Attachment A

Replace page 5.4-1 with attached 5.4-1 through 5.4-5.

5.4 Fuel Storage

FIGURE 4-1

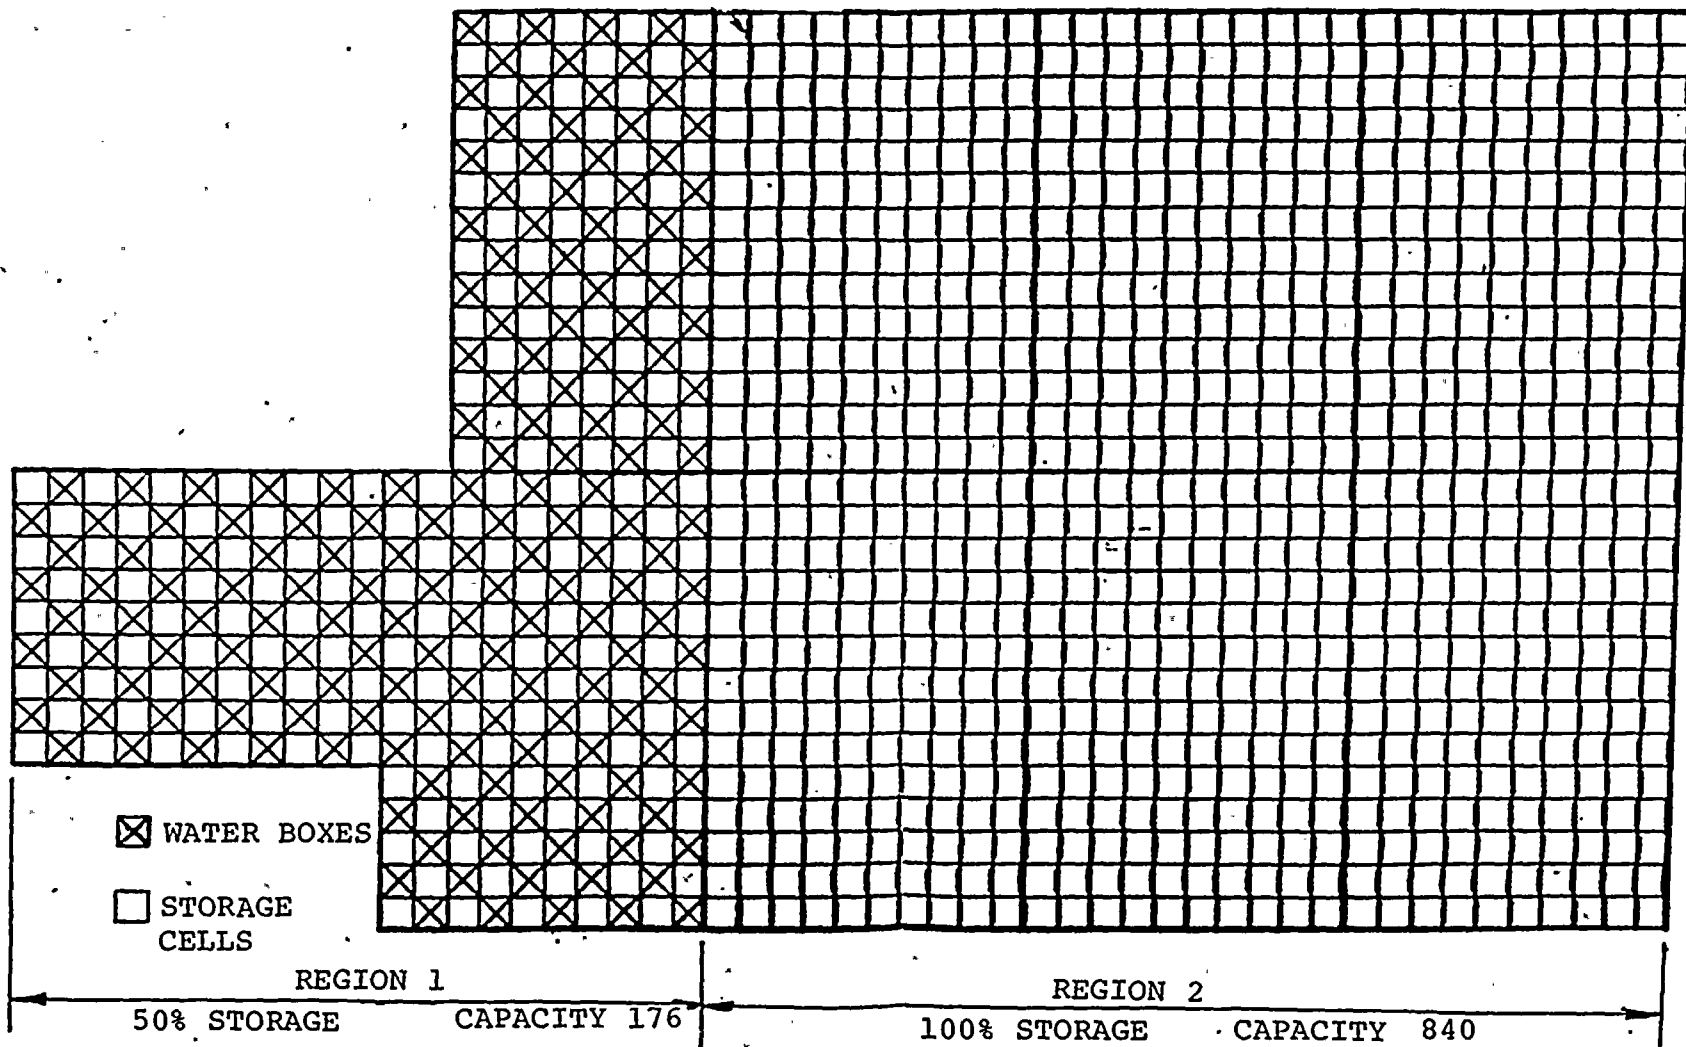
- 5.4.2 The spent fuel storage racks are divided into two regions as depicted on Figure 5.4-1. In Region 1 it is impossible to insert fuel assemblies in other than the prescribed locations. The fuel is stored vertically in an array with sufficient center to center distance between assemblies to assure $K_{eff} \leq 0.95$ for (1) unirradiated fuel assemblies delivered prior to January 1, 1984 (Region 1-15) containing no more than 39.0 gms U-235 per axial cm, and (2) unirradiated fuel assemblies delivered after January 1, 1984 containing no more than 41.9 gms U-235 per axial cm.

- 5.4.3 In Region 2 of the spent fuel storage racks, fuel is stored in a close packed array utilizing fixed neutron poisons in each of the stored locations. For discharged fuel assemblies to be stored in Region 2, (1) 60 days must have elapsed since the core reached hot shutdown prior to discharge and (2) the combination of assembly average burnup and initial U-235 enrichment must be such that the point identified by these two parameters on Figure 5.4-2 is above the line applicable to the particular fuel assembly design, therefore assuring that $K_{eff} \leq 0.95$.

REGIONS OF ACCEPTABILITY AND UNACCEPTABILITY
FOR STORAGE OF SPENT FUEL IN REGION 2

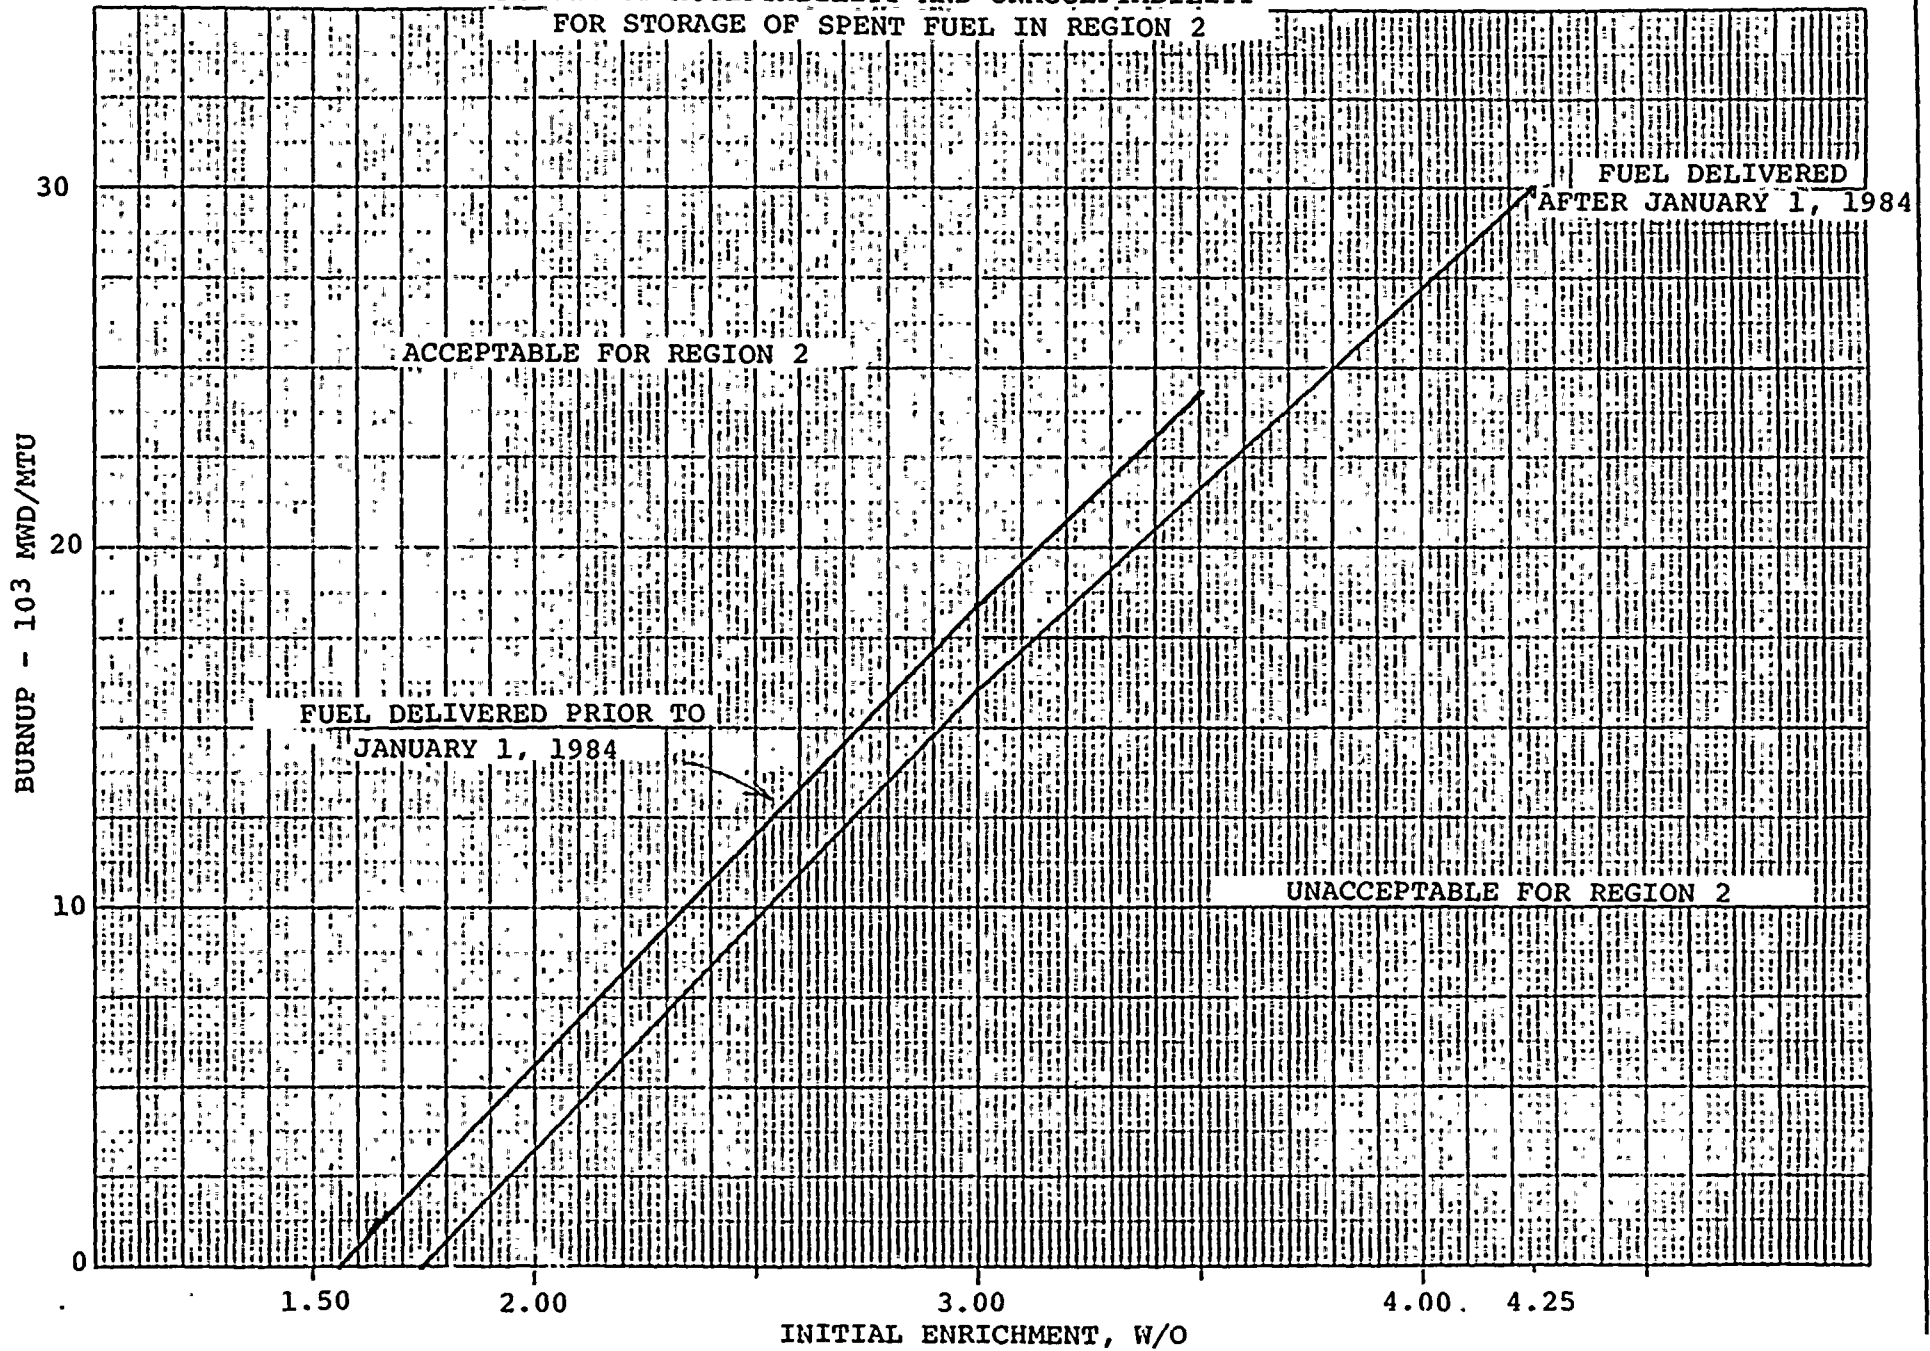
The two curves of Figure 5.4-2 divide the fuel assembly designs into two groups. The first group is all fuel delivered prior to January 1, 1984. This incorporates all Exxon and Westinghouse HIPAR designs used at Ginna⁴. The second curve is for the Westinghouse Optimized Fuel Assembly design delivered to Ginna beginning in February 1984³.

associated with the time between measurements and updates of core burnup. The curves of Figure 5.4-2 incorporate the uncertainties of the calculation of assembly reactivity.³

FIGURE 1-1

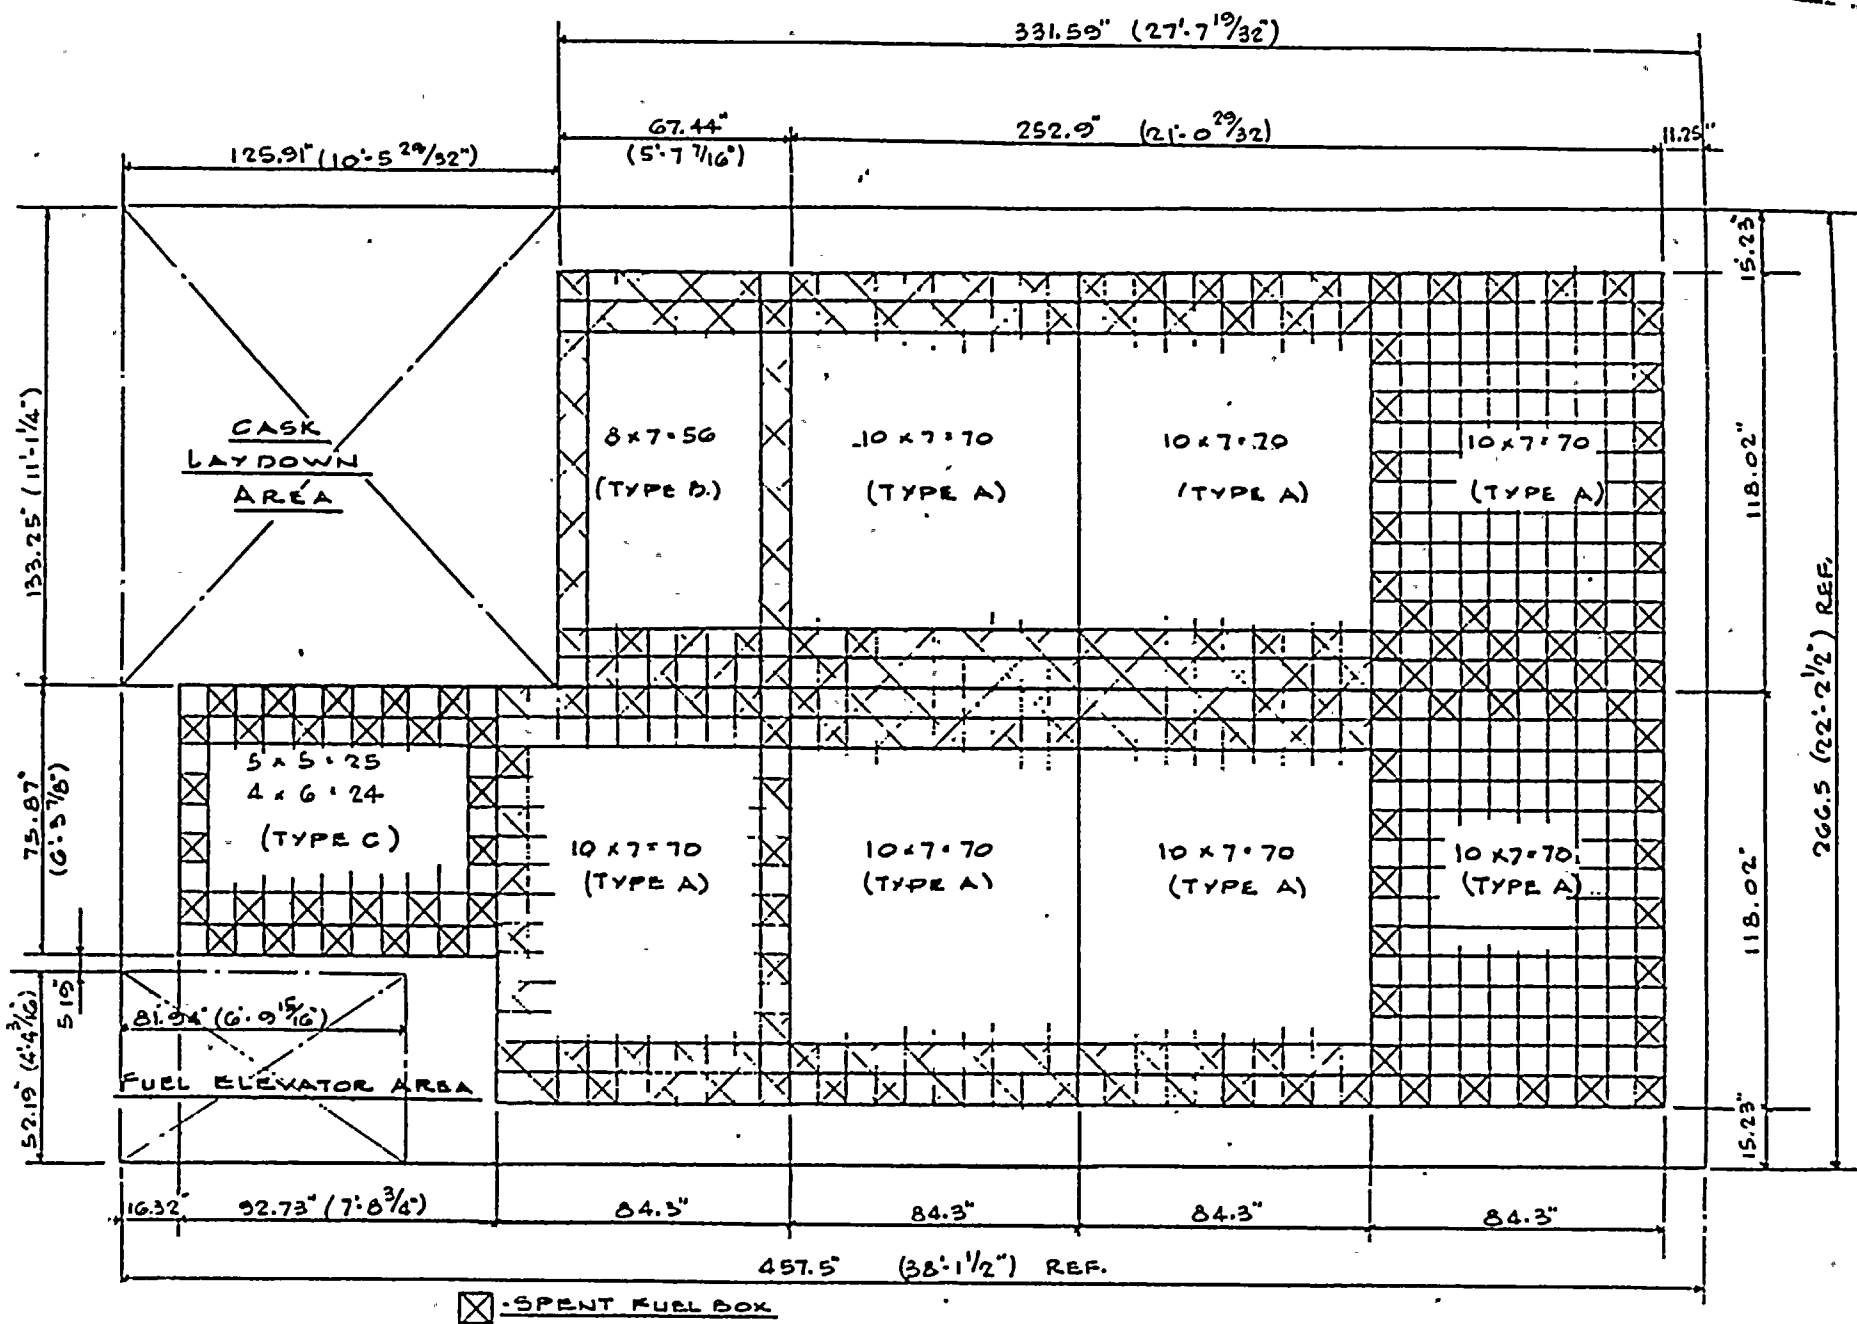
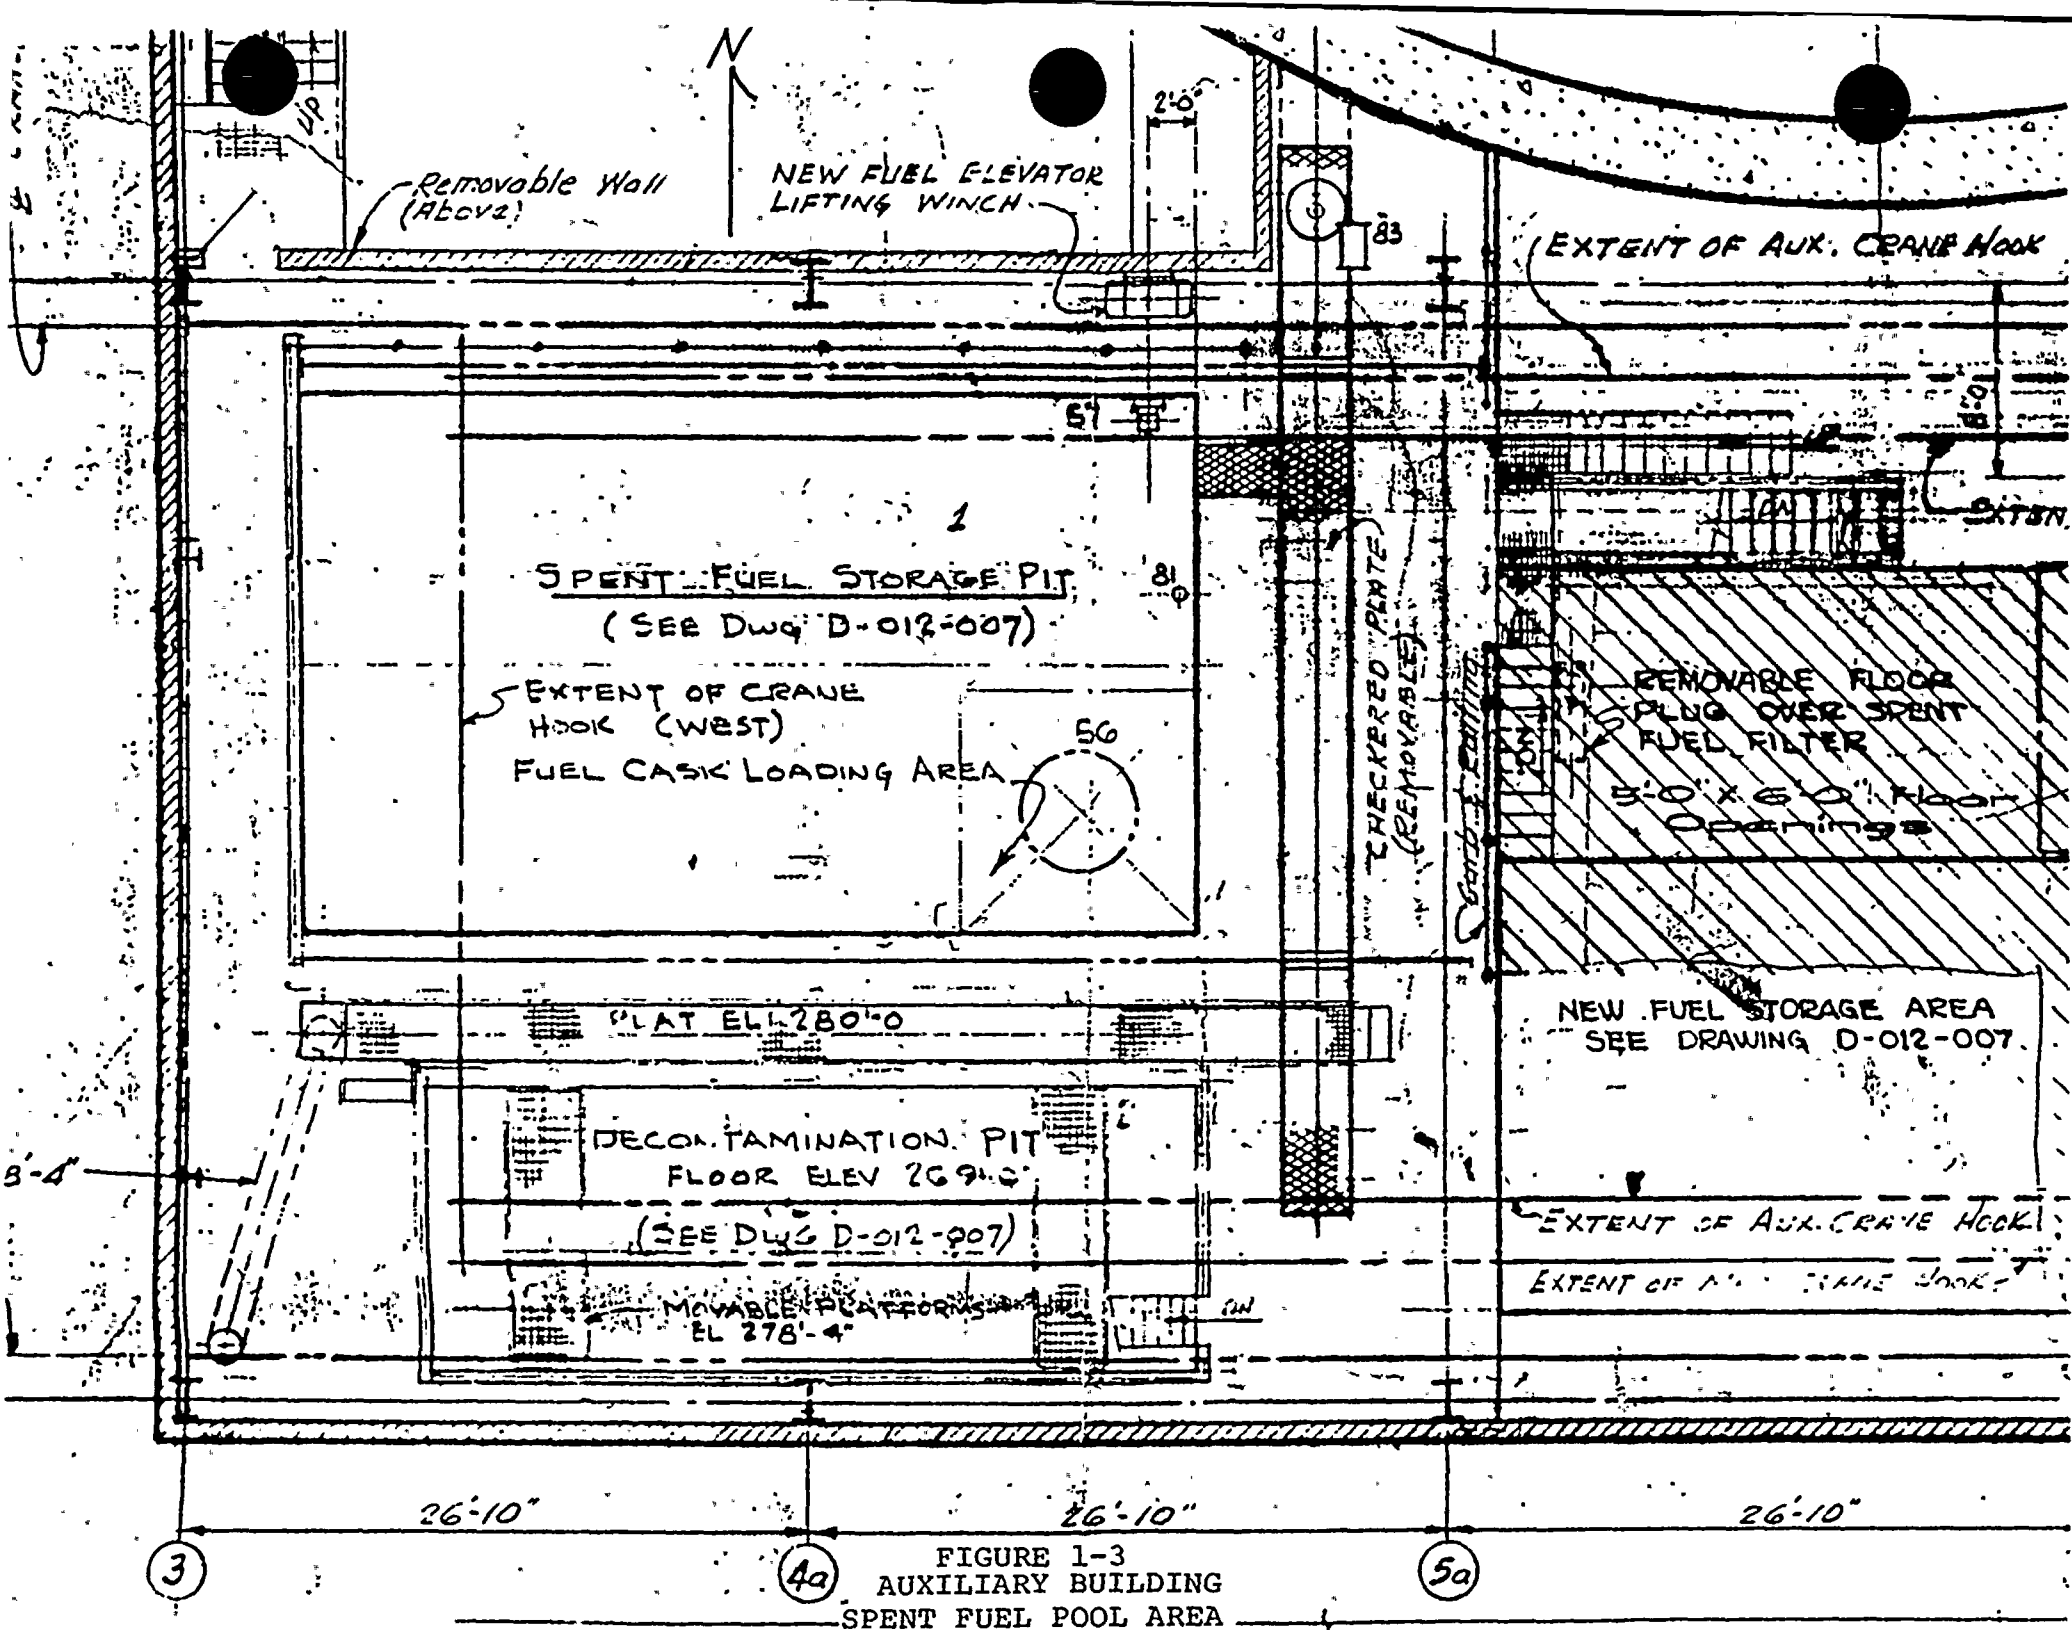
The proposed modification to the spent fuel storage racks will involve only the six west-most rack modules (Figure 1-1). These racks will be removed from pool and modified so that fuel assemblies can be stored in what were the water box locations. The remaining three rack modules will not be modified. The modifications will provide an additional 420 storage locations resulting in a total capacity of 1016*. The six modified racks will be designated Region 2 and will be used for fuel that satisfies certain burnup criteria and has cooled for at least 60 days. The

Comment: As a result of step 1, at least 8 empty rows of fuel cells will be between the divers and any spent fuel (Figure 1-1).
